ARM ETM
ETB11 (TM070)
Errata Notice

This document contains all errata known at the date of issue in releases up to and including revision r0p1 of Embedded Trace Buffer for ETM11 (ETB11)

311060: Scan Enable incorrectly factored into ETB11 Trace RAM Write Enable

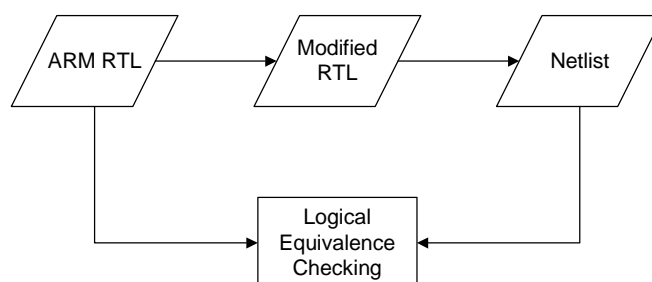
When the SE (Scan Enable) input to ETB11 is high, the Write Enable to the ETB11 Trace RAM is always active.

This can result in random data being written into the RAM and means that the RAM interface cannot be fully tested with full-sequential ATPG patterns.

Investigation using TetraMAX (version 2002.05-3) to generate full-sequential stuck-at ATPG patterns shows the difference in fault coverage with the Write Enable (WE) to the RAM forced low or forced high is negligible (99.77% with WE forced high and 99.69% with WE forced low).

The WE term in Etb11SRAMIntf.v (line 153) can be changed to:

```
assign WE = WEbus & {4{~SE}};
```

This forces WE inactive when SE is high. This modification does affect the functional operation of ETB11.

403350: ETB RAM location 0x0 might be corrupted when using the ETB RAM as system memory

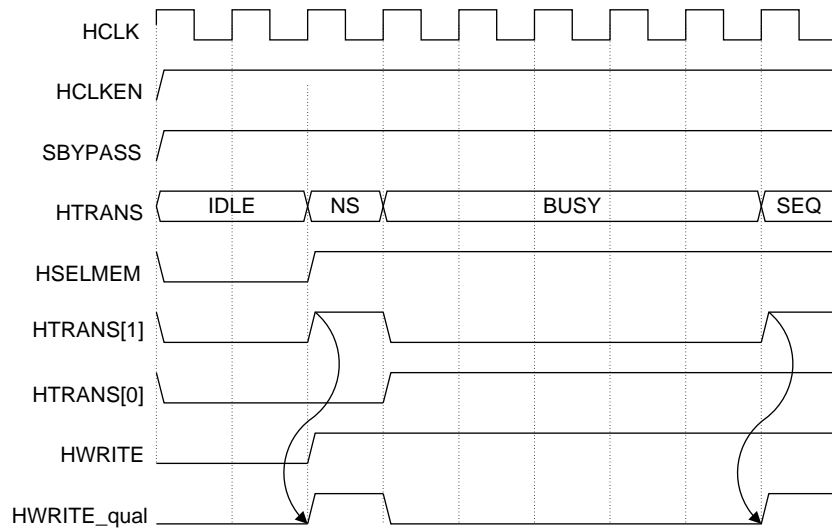
The AMBA AHB specifications allow a master to insert BUSY cycles during a burst transfer. An attempt to write to the ETB11 via AHB while HTRANS is set to BUSY for at least 5 cycles will corrupt location 0x0 in the ETB11 RAM.

- SBYPASS set
- A burst transfer of at least two items with 5 BUSY cycles between items
- HWRITE set for the entirety of the burst transfer
- HSELMEM set for the entirety of the burst transfer

The AHB master driving the ETB11 might assume that the IDLE transaction will always result in a zero wait-state response. This erratum might cause the AHB master to drive a new non-IDLE transaction on the AHB interface while HREADYMEM is low and therefore causing the ETB11 to miss the new transaction.

The non-IDLE transaction might have incorrect data returned in the case of a read transaction, or a write transaction might be performed incorrectly in the ETB11.

The HWRITE signal must be qualified by HTRANS[1] before being connected to the ETB11.

```
assign HWRITE_qual = HWRITE & HTRANS[1]
```

424163: ETB11 AHB interface might respond incorrectly to IDLE transactions**Status**

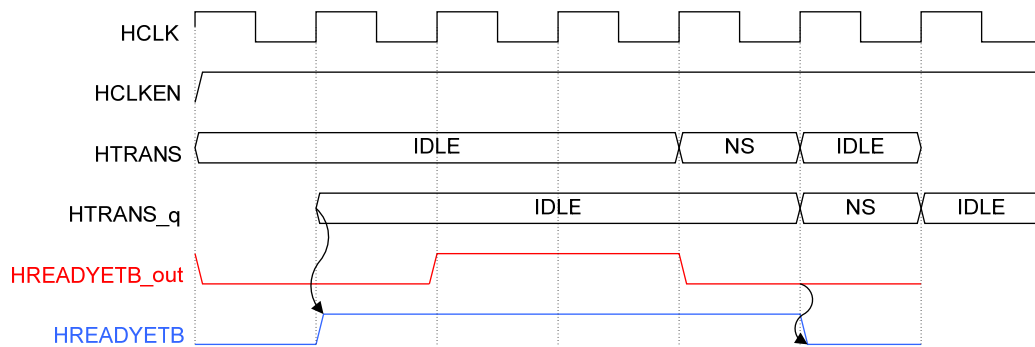
The AMBA AHB specification requires that a slave must respond to an IDLE transaction with a zero wait-state OK response. The ETB11 might not always respond with a zero wait-state OK response to IDLE transactions.

The HREADYMEM output from the ETB11 will unexpectedly be driven low during the data phase of the IDLE transaction, dependent on a certain internal state of the ETB11.

The AHB master driving the ETB11 might assume that the IDLE transaction will always result in a zero wait-state response. This erratum might cause the AHB master to drive a new non-IDLE transaction on the AHB interface while HREADYMEM is low and therefore causing the ETB11 to miss the new transaction.

The non-IDLE transaction might have incorrect data returned in the case of a read transaction, or a write transaction might be performed incorrectly in the ETB11.

The HREADYETB output from the ETB11 must be qualified based on whether an IDLE transaction is in progress. It is important that this is done during the data phase of the transfer (second cycle) and therefore a registered version of HTRANS should be used. While this registered version of HTRANS is b00 HREADYETB must be high.

This can be achieved with the following logic applied to HREADYETB output from the ETB11 creating a new HREADY output.
